RFB NO. 109061 - ADDENDUM NO. 2

WINDOW REPLACEMENT

HENRY VILAS ZOO ADMINISTRATION BUILDING

EXTERIOR WALL DETAILS

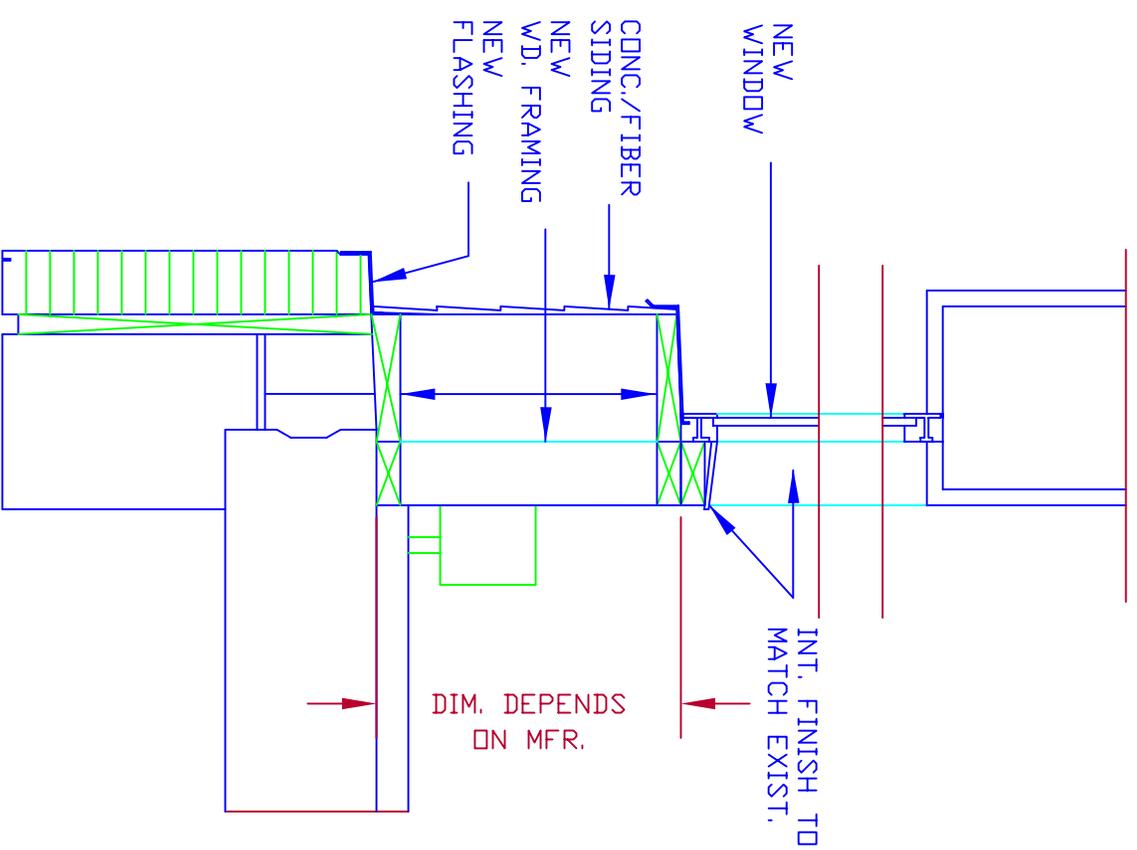
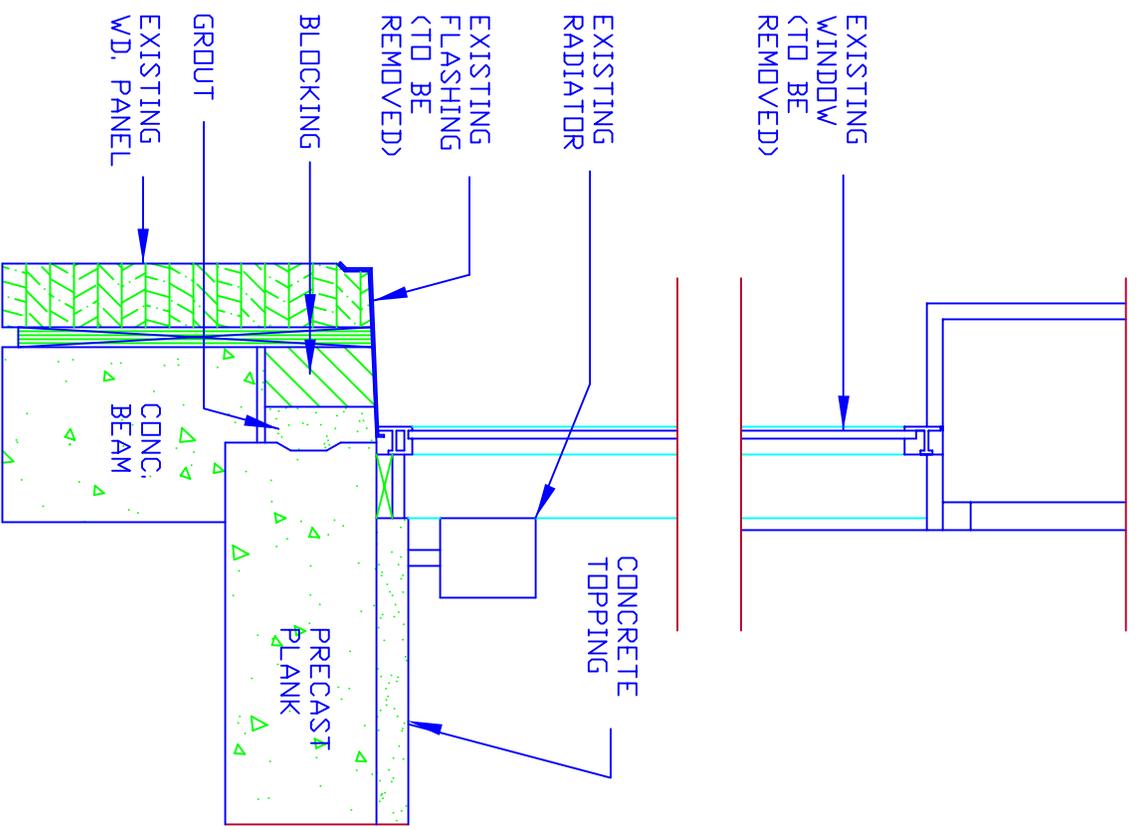
A sheet of exterior wall details is attached to this Addendum. This sheet has a detail of the existing exterior wall and a detail of the new exterior knee wall. If the new windows are smaller than the existing rough opening, construct the knee wall according to this detail and according to the specifications.
